SERVICE BULLETIN

No. 292 72 2100

ARRIEL 2 B - B1 - C - C-PM - C1 - C2 - S1

Subject: Module M05 (reduction gearbox). M04/M05 coupling sleeve with retaining ring which spreads load over bearing surface.

ANNEXE 1 / APPENDIX 1

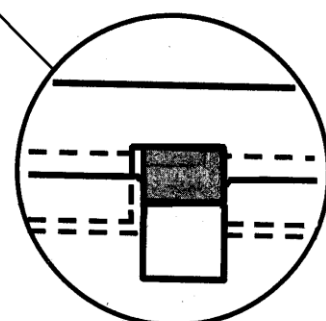
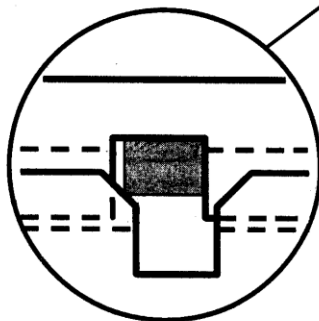
This modification consists of replacing the M04/M05 coupling sleeve.

The new M04/M05 coupling sleeve has undergone the following improvements:

- elimination of chamfers at groove of stop,
- reduction of diameter of sleeve groove.
